DESIGN ADVISORY BOARD Wednesday October 12, 2016 at 3:00 PM Conference Room 12, City Hall, Burlington, VT Agenda

MEMORANDUM

To: The Design Advisory Board
From: Mary O'Neil, AICP, Principal Planner
RE: ZP17-0388CA/MA; 66, 72, 80, 94 and 96 Colchester Avenue; 27 and 49 Fletcher Place
Date: **WEDNESDAY** October 12, 2016

2 NORTH ELEVATION BLDG 2
3/32" = 1'-0" Referenced From A102

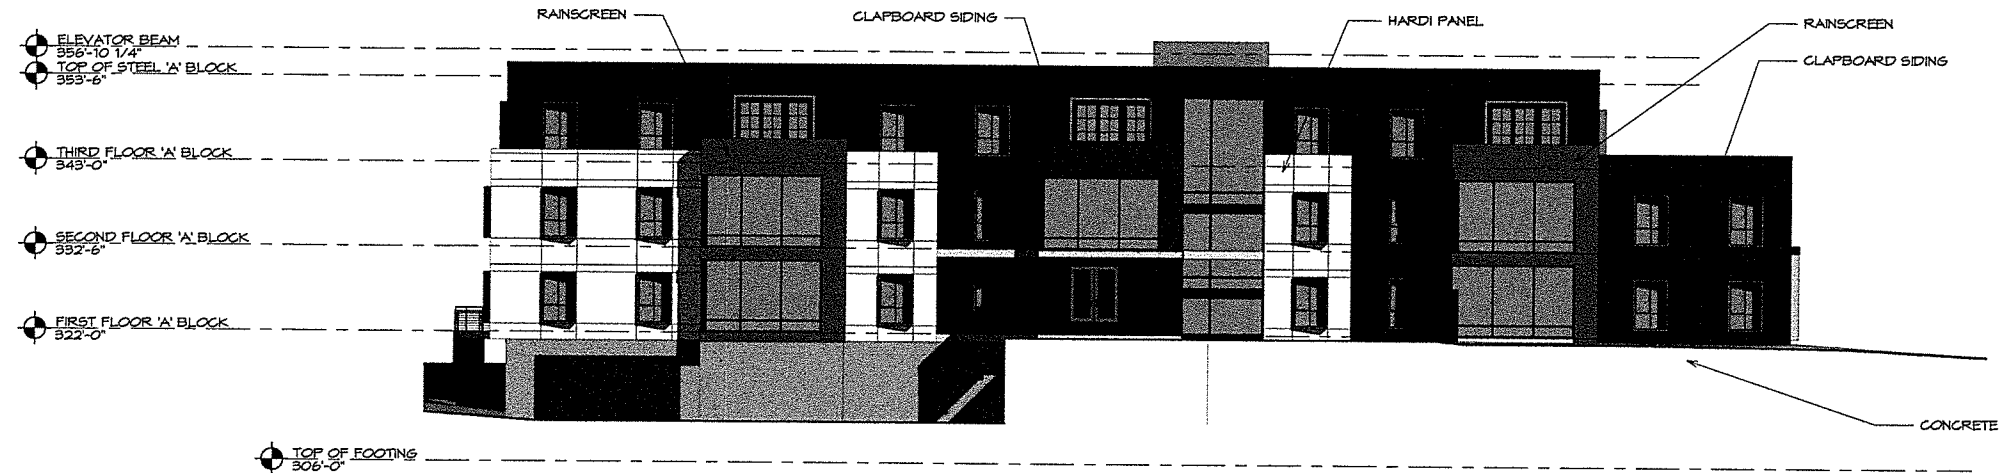
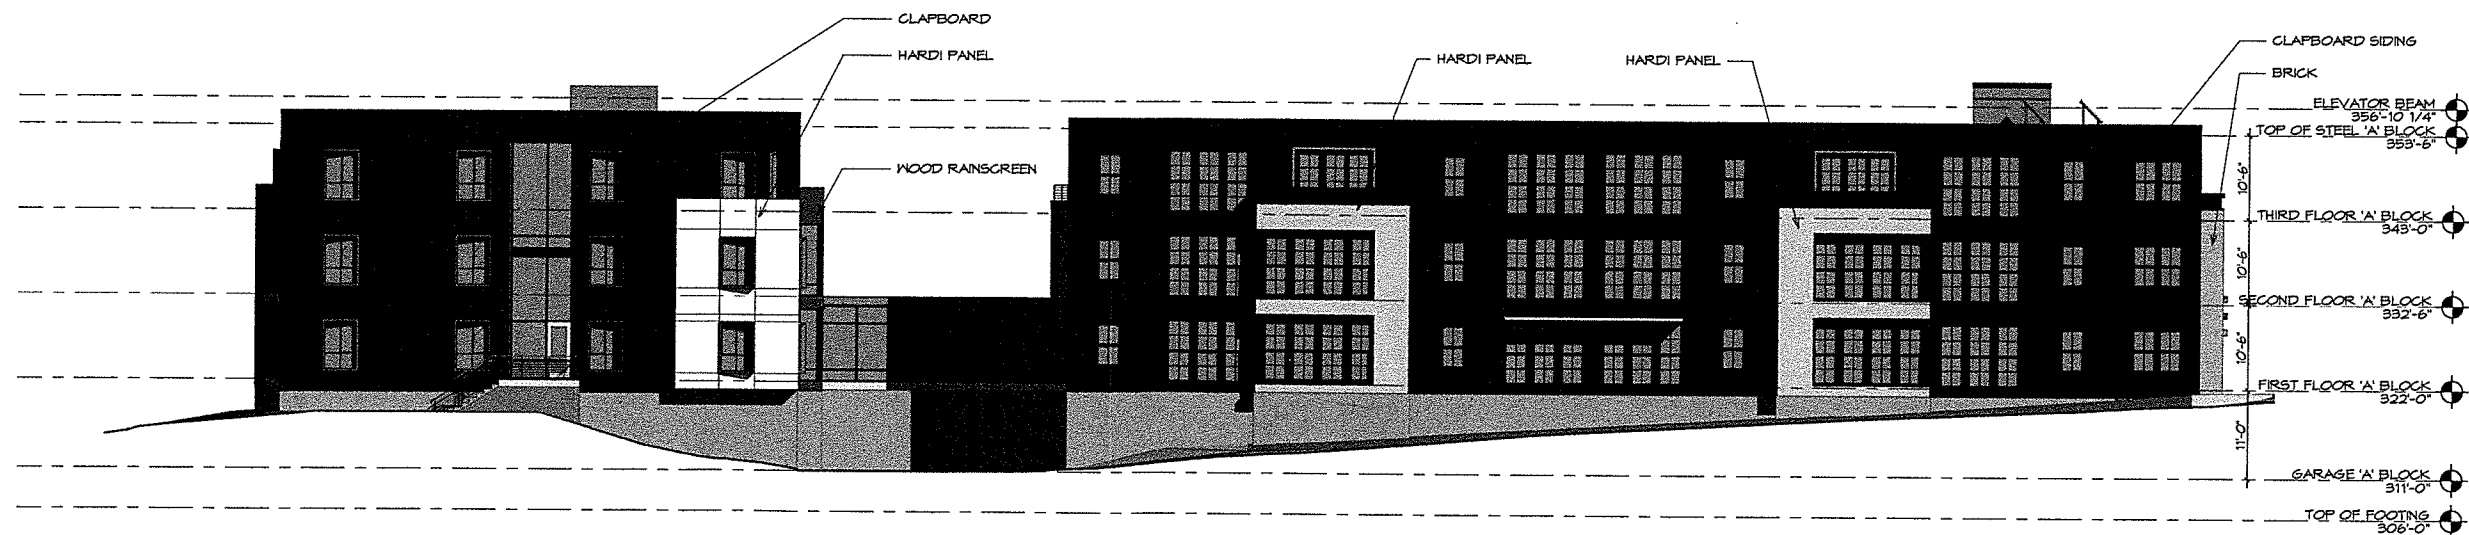
Windows on the southerly building have a less defined arrangement on the south (Colchester Avenue) façade, with the principal entry flanked in plate glass, partnered with triple ganged windows on three floors. The westerly elevation displays greater rhythm and arrangement. The west elevation of the northerly building is more staid, with a central spine (of glass, or metal?) through which an entry is located. Easterly elevations of both buildings illustrate the desire to distinguish one building from the other with material and window arrangement. The connector between the two is also among glass or metal panels, with a double entry door.

The north elevation of the northerly building now enjoys more glazing, with apparent doors onto balconies on the upper floor. Similar features are evident on the south elevation of the same wing.

Garage - single bay, gable front entrance. Clapboard and vertical planks, returning cornice, corner boards. Asphalt shingle roof, single overhead door, cement foundation. (10' x 14') c.1930-40.

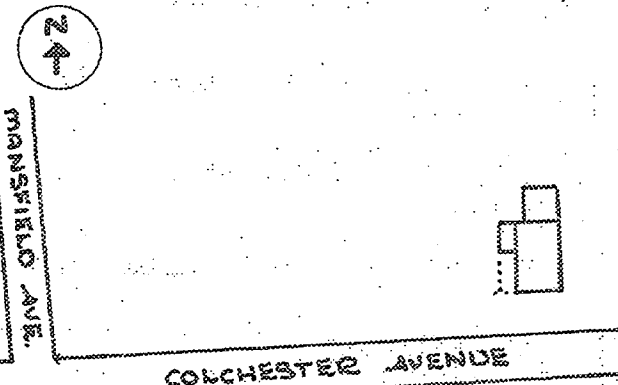
The single car, wood frame garage behind 72 Colchester Avenue is proposed to be removed to accommodate the new circulation and parking plan. It, also, is listed on the Vermont State Register as associated with 72 Colchester Avenue, and dates from 1930-50. In appearance and presentation, the small accessory building clearly recalls the single family residential use of the property. See Section 5.4.8 (d), below.
